NORTHWEST ENVIRONMENTAL ADVOCATES

July 5, 2024

Re: Proposed Updates to the Washington Water Quality Standards for Natural Conditions Provisions in WAC Chapter 173-201A

Figure 3.21 Olalla-Lookingglass Creek temperature simulation results.

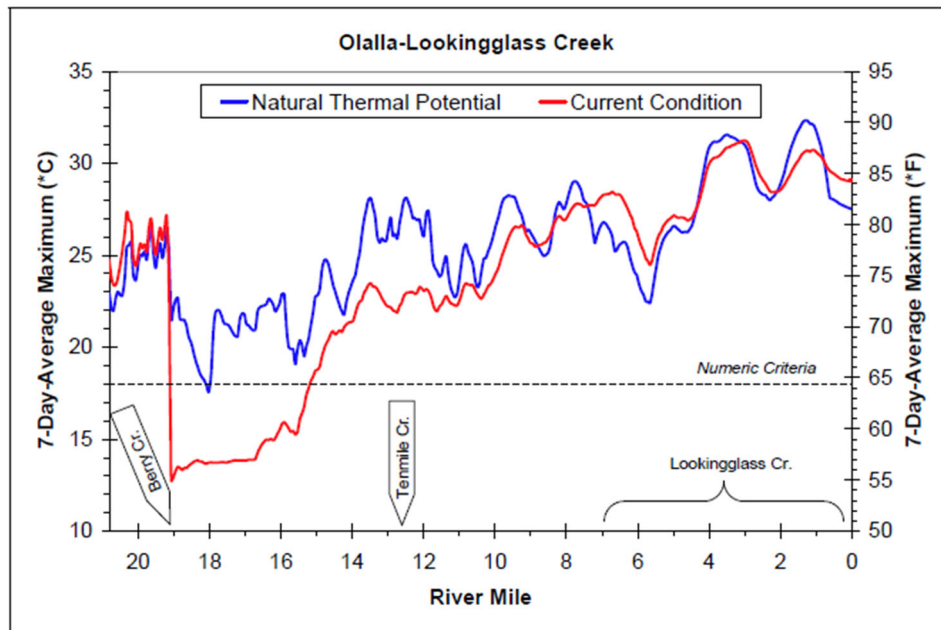
“Regional Guidance”). To provide a feel for why EPA’s past approvals of the use of NCC-derived criteria were so flawed (in both Oregon and Washington), one only need look at EPA’s approval of Oregon’s Umpqua TMDL that was based on that state’s now-disapproved NCC. One example of the superseding, purportedly “natural,” temperatures was 32.5° C, as demonstrated here:

Oregon DEQ, *Chapter 3, Umpqua Basin Stream Temperature TMDL* at 3-59.¹ It is very much worth noting that 32.5° C is, according to EPA’s Regional Guidance and Ecology, lethal to salmon within seconds. Regional Guidance at 33 (“Exposures of less than 10 seconds can cause instantaneous lethality at 32°C (WDOE, 2002).”). This, as well as other examples, none of which were evaluated by the federal court in the Oregon case or by EPA in its Oregon disapproval, demonstrates that just because an agency has deemed a temperature “natural” through modeling does not in any way mean that it has correctly made that determination. Salmonids could not have lived, let alone thrived, in the NCC-derived temperatures.

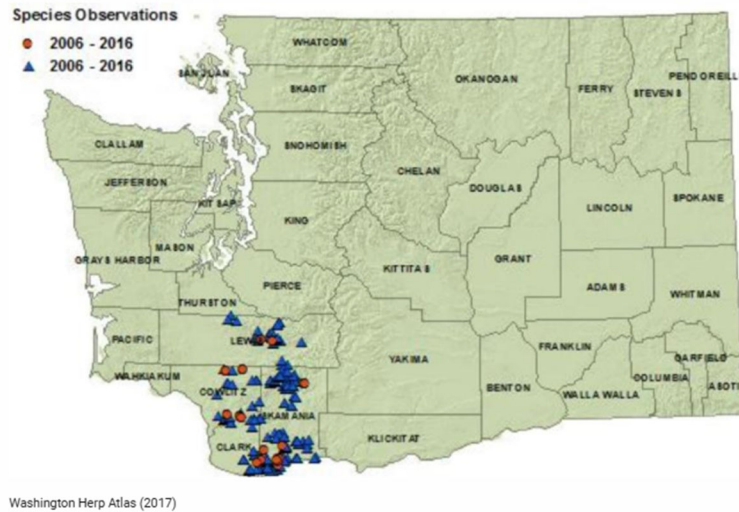
of criteria, one that presumably would require the agency to have a process by which it evaluated the proposed superseding NCC criteria after they were derived to see if they would, in fact, be protective of the designated and existing uses. Not only is there no “test” of the resulting superseding criteria based on the biology of the species affected but there is no consideration given to the other conditions that would have been present with the purportedly natural water quality.

This is not hypothetical. For example, in using the NCC in the Palouse River TMDL, Ecology concluded:

Moderate reductions in water temperature are predicted for hypothetical conditions with system potential mature riparian vegetation. Potential reduced maximum temperatures under critical conditions are still predicted to exceed both the 17.5°C and 20 °C criteria and the 22°C salmonid lethality limit. However, under the more moderate summertime conditions represented by August 25-31, 2007, system potential mature riparian vegetation is expected to result in maximum temperatures that do not exceed 22°C on many parts of the Palouse River.

Ecology, *Palouse River Temperature Total Maximum Daily Load Water Quality Improvement Report and Implementation Plan* (July 2013) (hereinafter “Palouse TMDL”) at 43 (emphasis added). How are temperatures above the salmonid lethal limit protective of these species?

Figure 17. Predicted 7-day maximum and minimum temperatures in the Palouse River for July 6-12, 2007.

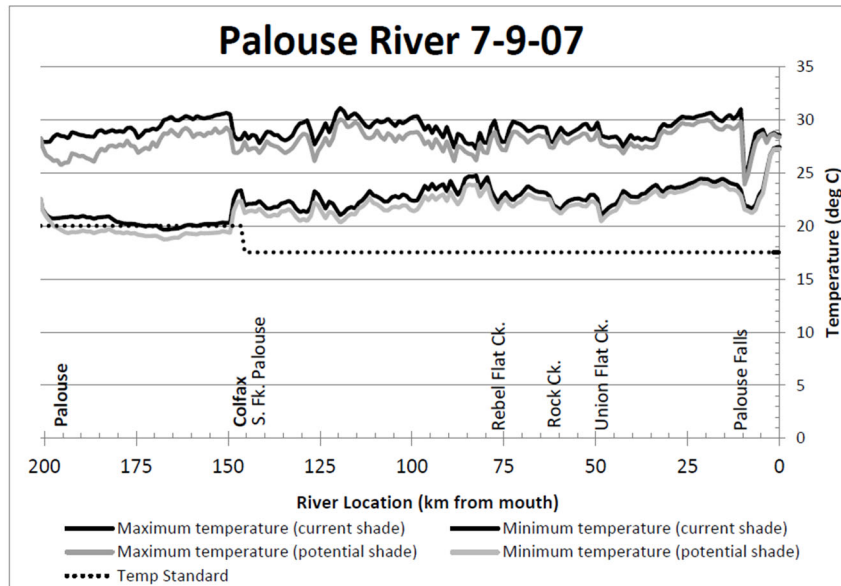
In other Washington TMDLs, Ecology uses the NCC to derive purportedly natural temperatures but is vague about what the resulting target is. The Palouse TMDL is an example. To start with, the Palouse TMDL omitted all non-shade anthropogenic inputs. *See Palouse TMDL* at 45. Making the point discussed immediately above, Ecology stated that “tributaries were modeled only as inputs into the mainstem Palouse River, with a specified flow and temperature. Separate temperature models were not created for tributaries, and system potential temperatures were not estimated. However, it is expected that larger temperature reductions are possible in the tributaries than in the Palouse River with the implementation of system potential riparian vegetation.” *Id.* at 44. Next, it did not provide superseding criteria but, rather, a wide range of possible temperatures that the TMDL was aiming to achieve. *See id.* at 41 (“A system potential temperature is estimated for both a critical climactic condition, represented by July 6-12, 2007, and for a critical low-flow condition, represented by August 25-31, 2007. The system potential temperature approximates natural conditions.”), 43 (“Moderate reductions in water temperature are predicted for hypothetical conditions with system potential mature riparian vegetation. Potential reduced maximum temperatures under critical conditions are still predicted to exceed both the 17.5°C and 20 °C criteria and the 22°C salmonid lethality limit. However, under the more moderate summertime conditions represented by August 25-31, 2007, system potential mature riparian vegetation is expected to result in maximum temperatures that do not exceed 22°C on many parts of the Palouse River.”). The NCC results, presented as ranges are set out in two referenced graphs, one of which is shown here:

Id. at 42; *see also id.* at 43. These graphs show a range of temperatures, not criteria. The load allocations further demonstrate the circularity of the entire exercise and its extra-legal “know it when we see it” attributes. “The load allocation for the mainstem Palouse River below the Washington/Idaho state line, and the two miles of each study area tributary nearest its mouth, is the potential shade that would occur from system potential mature riparian vegetation.” *Id.* at 45.
